ROCKY FLATS SITE

REGULATORY CONTACT RECORD

Purpose: Grading the Slump Area South of FC-4 and Former Building 991

UNITED STATES
DEPARTMENT OF ENERGY
LEGACY MANAGEMENT
ROCKY FLATS SITE
BUILDING AREA 991 SLUMP REPAIR

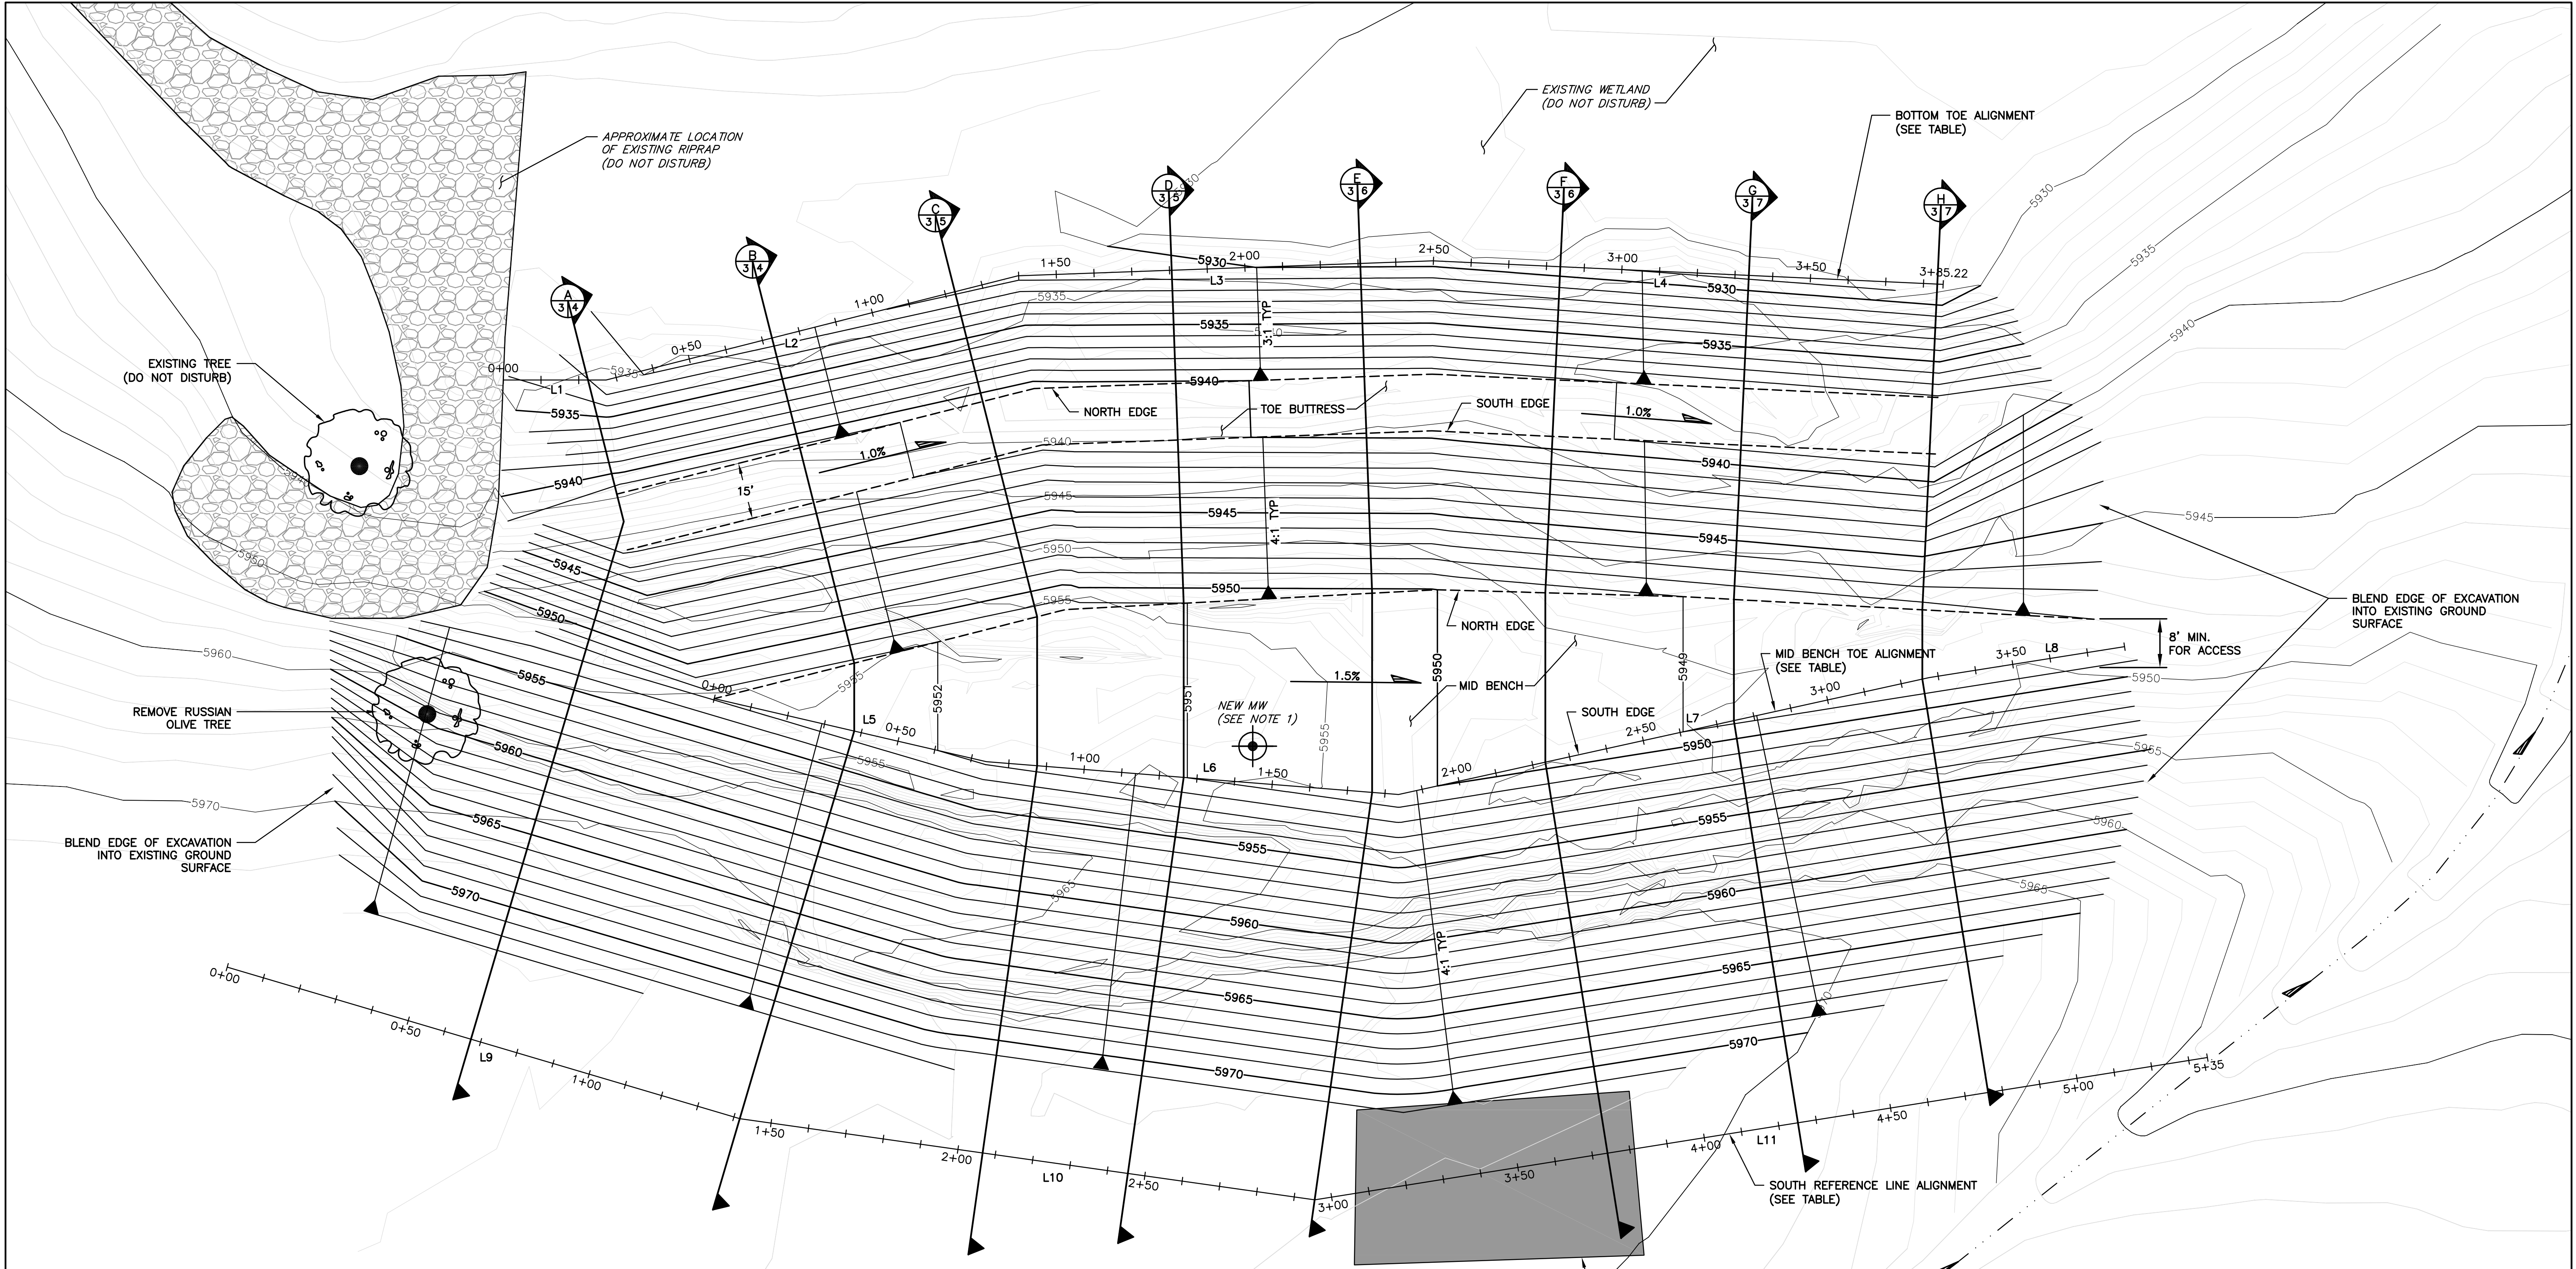
DOE, CDPHE, and Stoller staff informally consulted on August 30, 2007, on the regrading concept, and the attached S.M. Stoller Conceptual Design shows the grading location, depth of excavation, and placement of fill based on the outcome of those discussions. Note that Design Sheet 3 also shows the location of former Individual Hazardous Substance Site (IHSS) 154, the Pallet Burn Site, which is discussed in more detail below.

- IHSS 154 (PAC 900-154), Pallet Burn Site – Oil-contaminated pallets and other wood debris were burned in this area, which is located south of the slumping soils, just north of FC-5. The conceptual design drawing (Sheet 3) shows that the extent of regrading just touches the northern extent of IHSS 154, approximately between the southern end of Sections E and F (Sheets 6 and 7). Burning activities were conducted in 1965 and the area was removed sometime in the 1970s. Characterization of this IHSS in 2002, as part of IHSS Group 900-2, resulted in three of six sample locations with detectable levels of arsenic, and two of the three locations had arsenic above the wildlife refuge worker (WRW) soil action level specified in the Rocky Flats Cleanup Agreement (RFCA), both at depths greater than 4.5 feet below the surface.

The proposed regrading may remove some soil adjacent to IHSS 154, but this would not significantly decrease the elevation of soils within IHSS 154. Prior to regrading, the

boundaries of IHSS 154 will be surveyed and marked. No excavation will take place inside the IHSS boundary.

GRADING PLAN

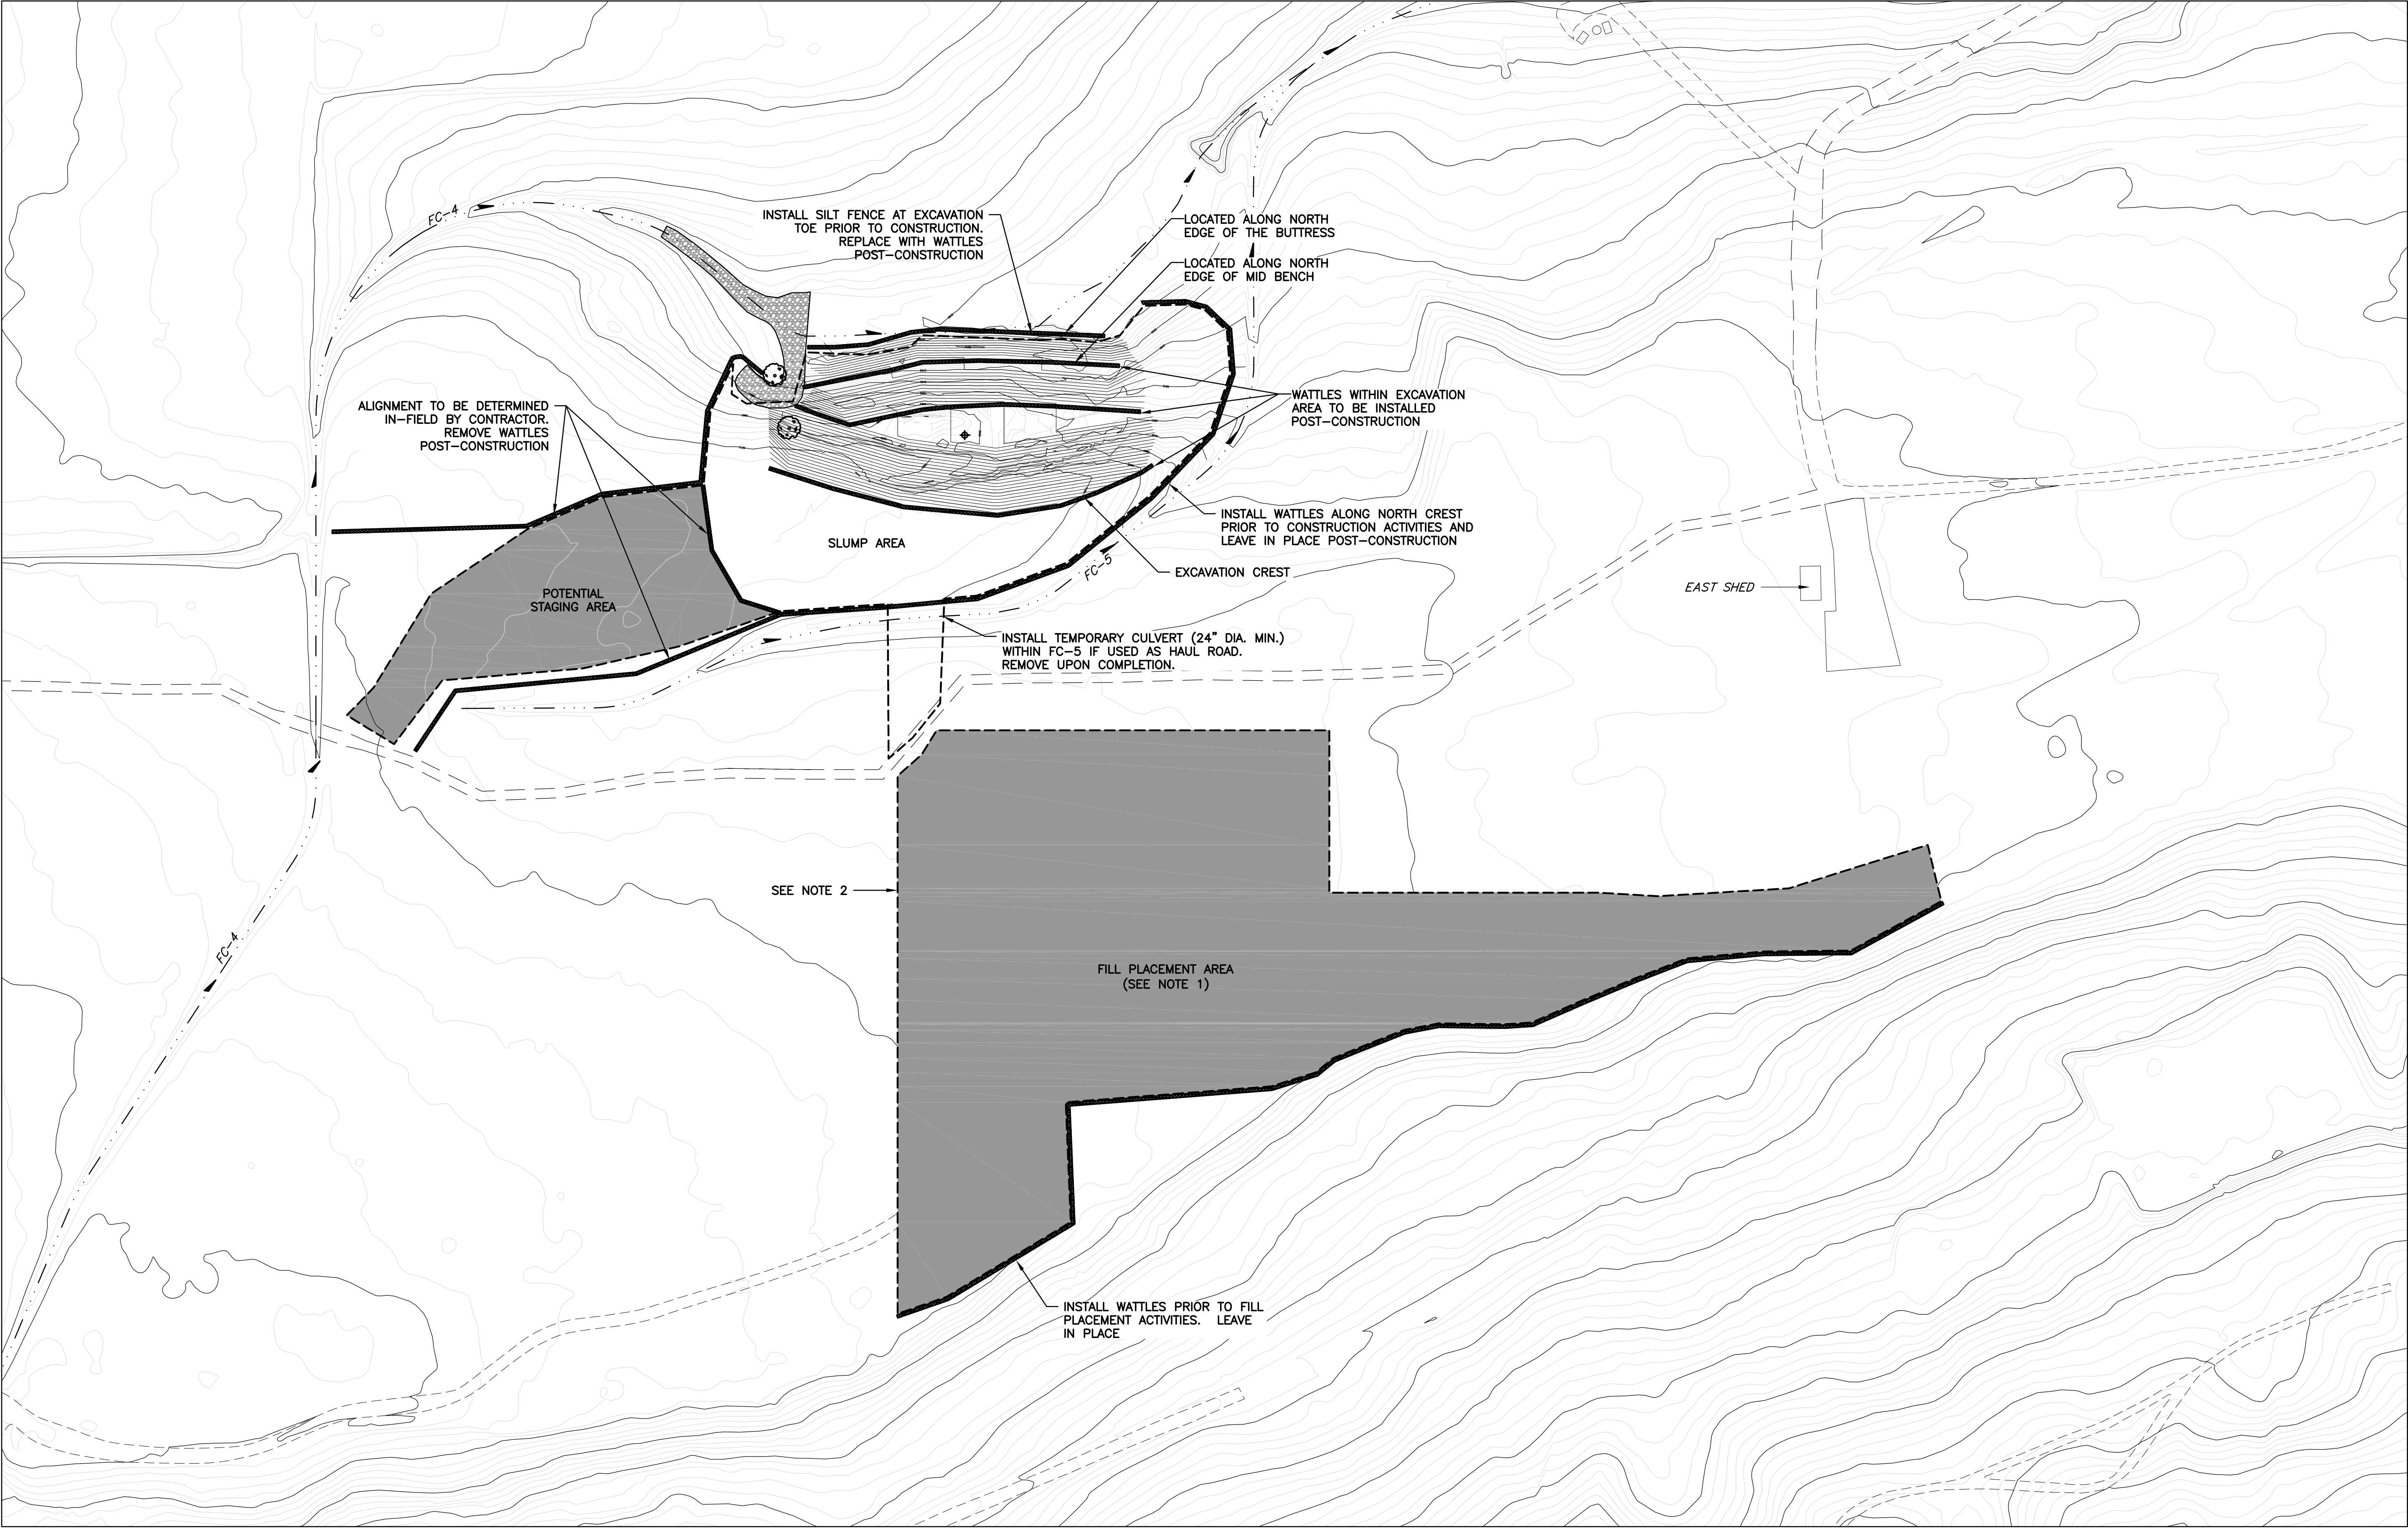
The regrading is projected to generate approximately 7,000 cubic yards of excess material. This soil will be spread at and adjacent to the former 903 Pad area (refer to Design Sheet 8), which will facilitate revegetation efforts in this area. The fill placement activity will conform with the applicable institutional controls, and the final elevation after fill placement and reseeded is expected to be slightly above the existing elevation. Erosion controls for the regrading excavation and fill activities will be employed in accordance with the Central Operable Unit (OU) Erosion Control Plan.
